Current Wellbore
Red Tank 31 State #004
30-025-33580-0000
Lea

Notice of Intent to PA – Procedure

Red Tank 31 State #004

30-025-33580-0000

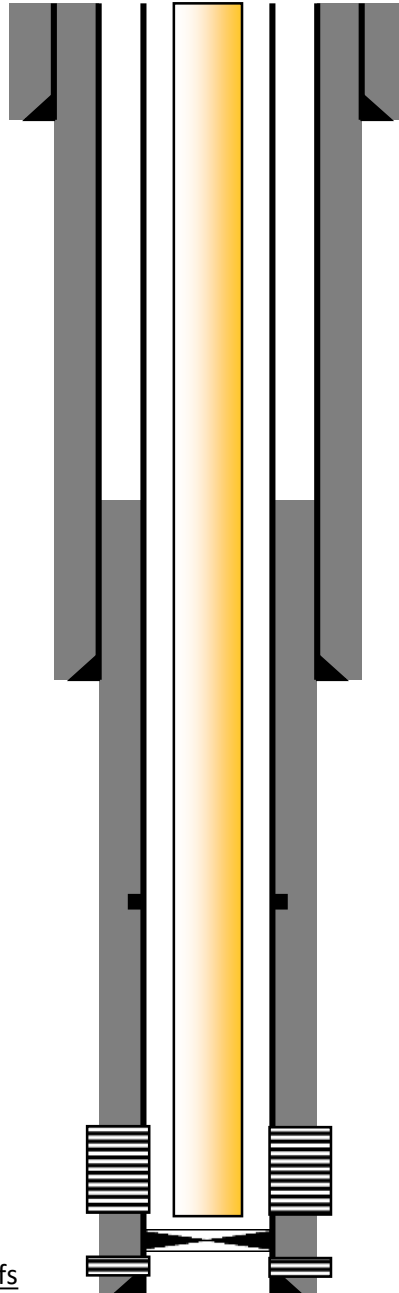
ADDITIONALLY, THE PERFORATIONS ADDED TO THE DELAWARE IN 2018 WERE NOT PREVIOUSLY REPORTED AND ARE NOT REFLECTED IN THE NMOCD WELL FILE. PLEASE SEE CURRENT WELLBORE DIAGRAM FOR DETAILS.

Proposed Wellbore
Red Tank 31 State #004
30-025-33580-0000
Lea

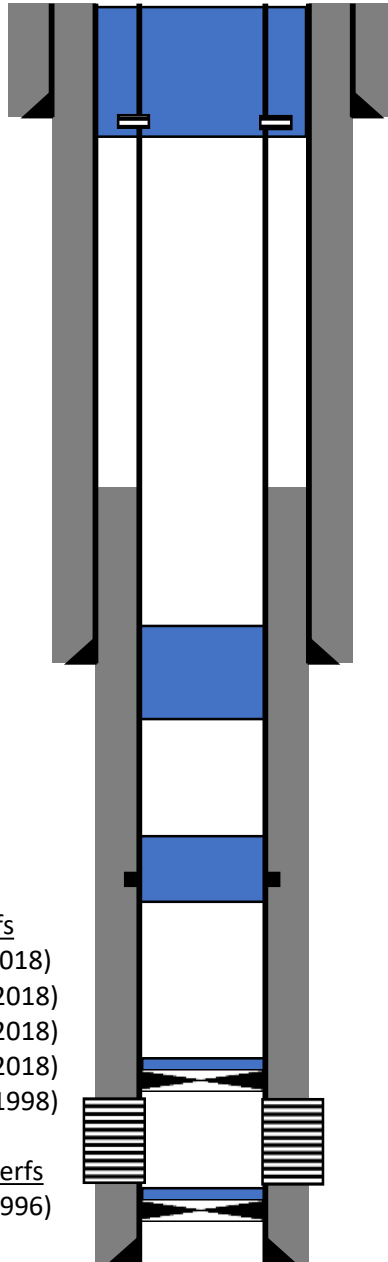
LPC Area Below ground marker send pics before backfilling hole

10# MLF between plugs. Utilize above ground steel tanks.
